**Subject:** Notice of Development Application

Attached is a notice of development application for expansion of the Lake Erie gravel mining operation. Please review and comment as appropriate.

RE: Ecology Comments on the Lake Erie Gravel Mine Expansion Project File # PL16-0556

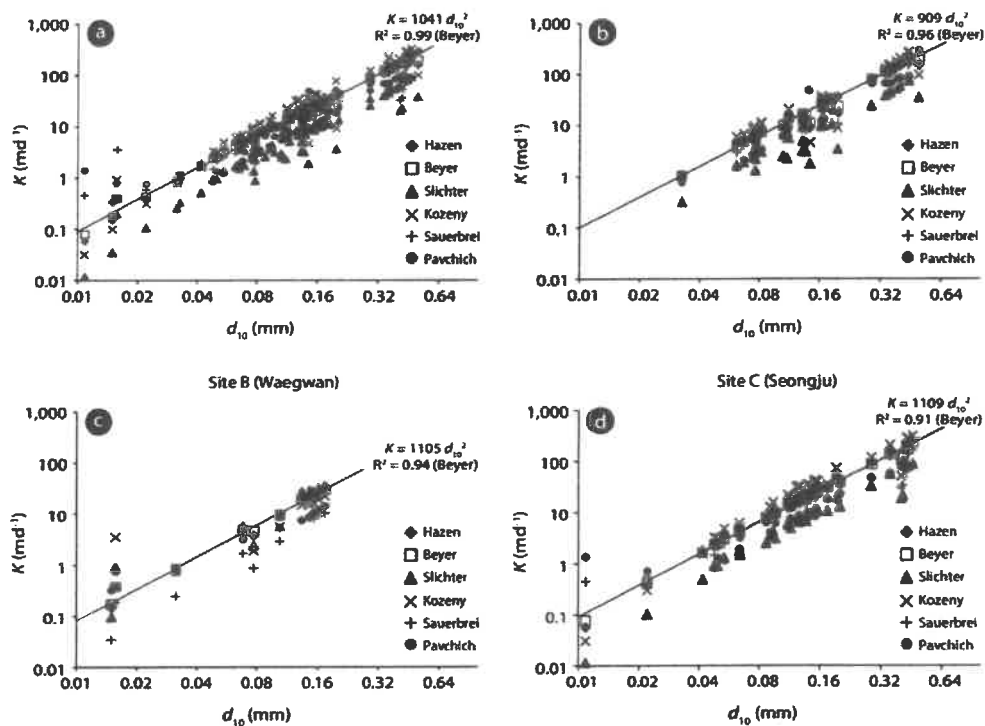
Finally, based on well-known hydrogeological characteristic of sediments (hydraulic conductivity, etc.) and the change of grain size and silt/clay content (as documented in the actual boring log) that intervals of perched water did occur but were either not reported or missed due to the method of drilling.

We respectfully submit three additional figures to support this observation. Figures 4a and 4b illustrate the range of Hydraulic Conductivities (K) measured and expected in granular material. Figure 5 is a section of the actual drilling log constructed as part of the subsequent study by Maul Foster Alongi (2017).

Figure 5. Section of boring log submitted by Maul Foster Alongi (2017).

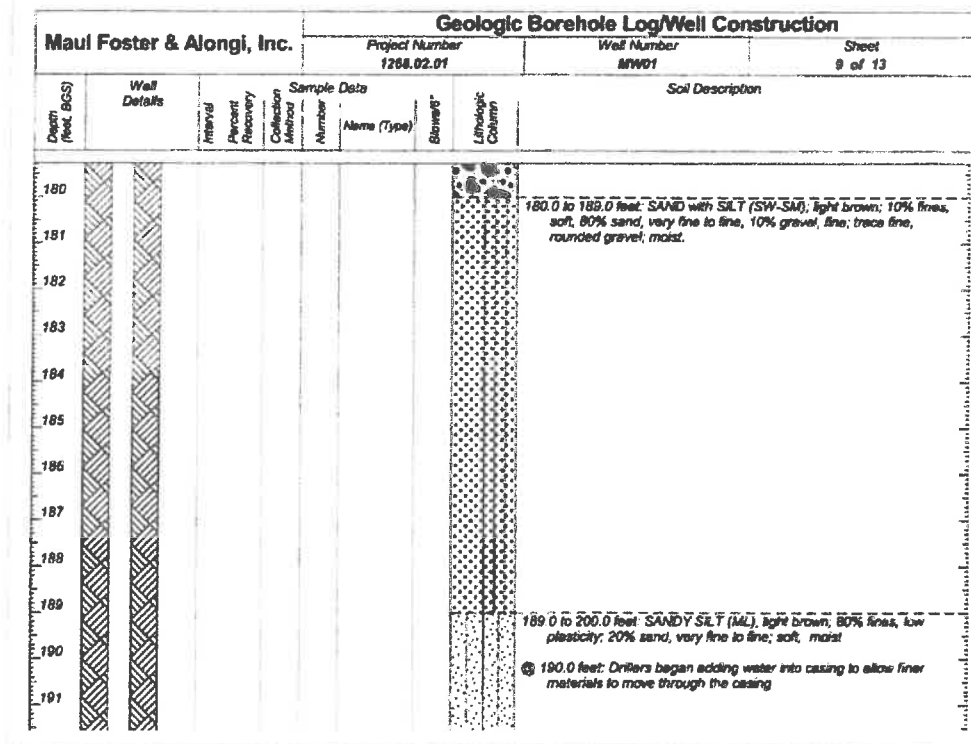
In summary, we are concerned that the current environmental investigation used to support the additional expansion is incomplete and could become demonstrably problematic in the event that the project is approved (in its current form) without consideration of the potential hydrogeological consequences or slide damage to our water main in the area of Dodson Canyon as well as slope instability issues in the area of Edith Point and Sunset Lane.

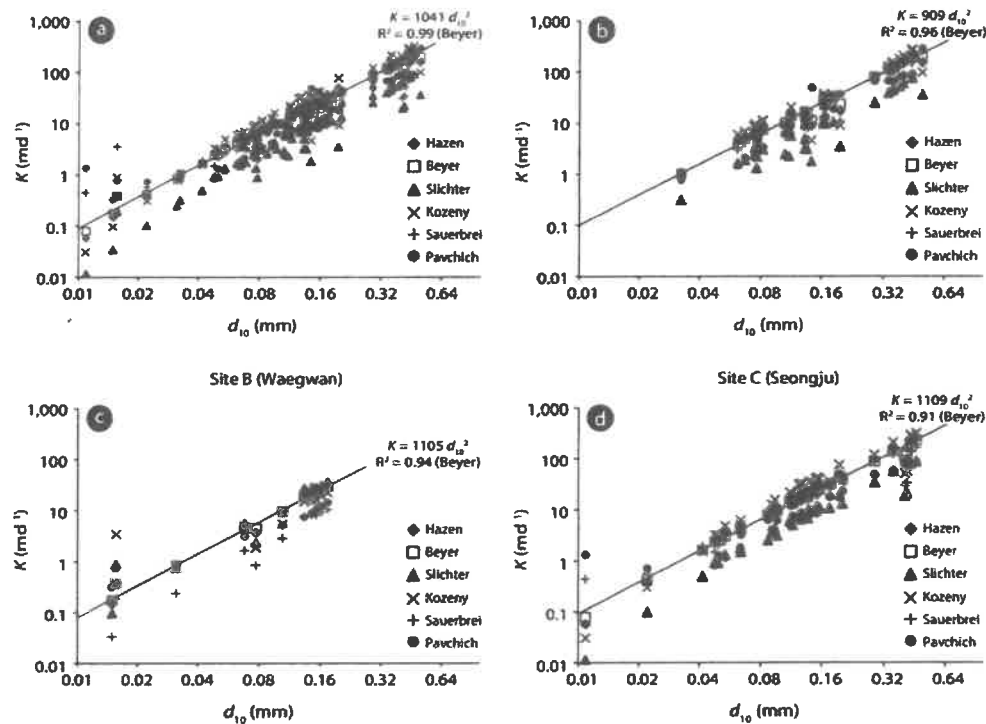
Finally, based on well-known hydrogeological characteristic of sediments (hydraulic conductivity, etc.) and the change of grain size and silt/clay content (as documented in the actual boring log) that intervals of perched water did occur but were either not reported or missed due to the method of drilling.

We respectfully submit three additional figures to support this observation. Figures 4a and 4b illustrate the range of Hydraulic Conductivities (K) measured and expected in granular material. Figure 5 is a section of the actual drilling log constructed as part of the subsequent study by Maul Foster Alongi (2017).

Figure 5. Section of boring log submitted by Maul Foster Alongi (2017).

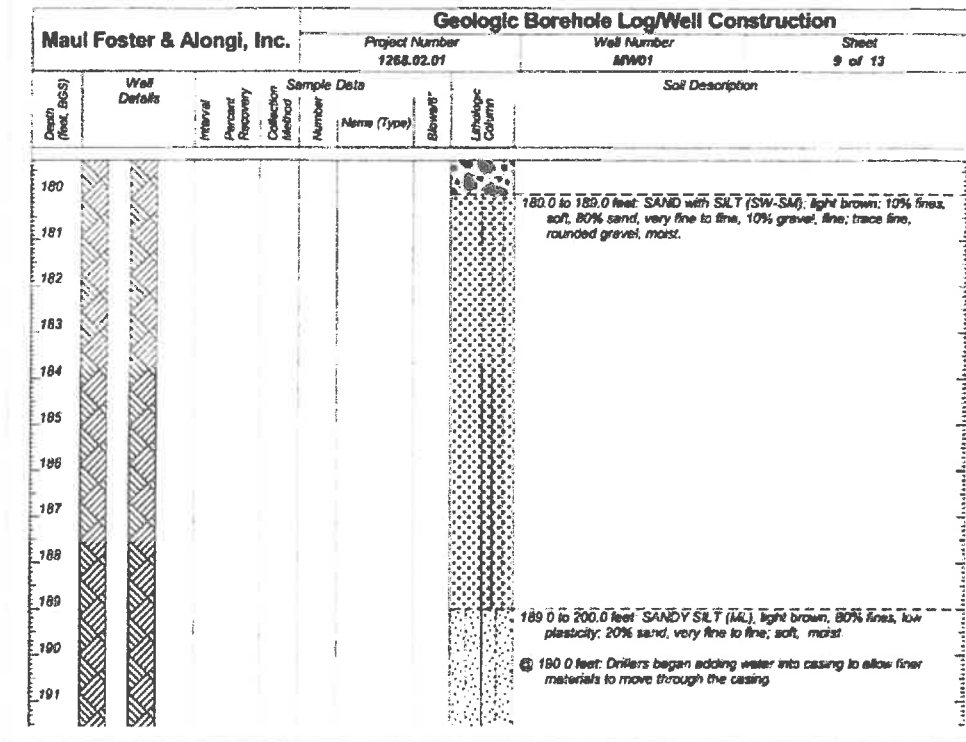
In summary, we are concerned that the current environmental investigation used to support the additional expansion is incomplete and could become demonstrably problematic in the event that the project is approved (in its current form) without consideration of the potential hydrogeological consequences or slide damage to our water main in the area of Dodson Canyon as well as slope instability issues in the area of Edith Point and Sunset Lane.
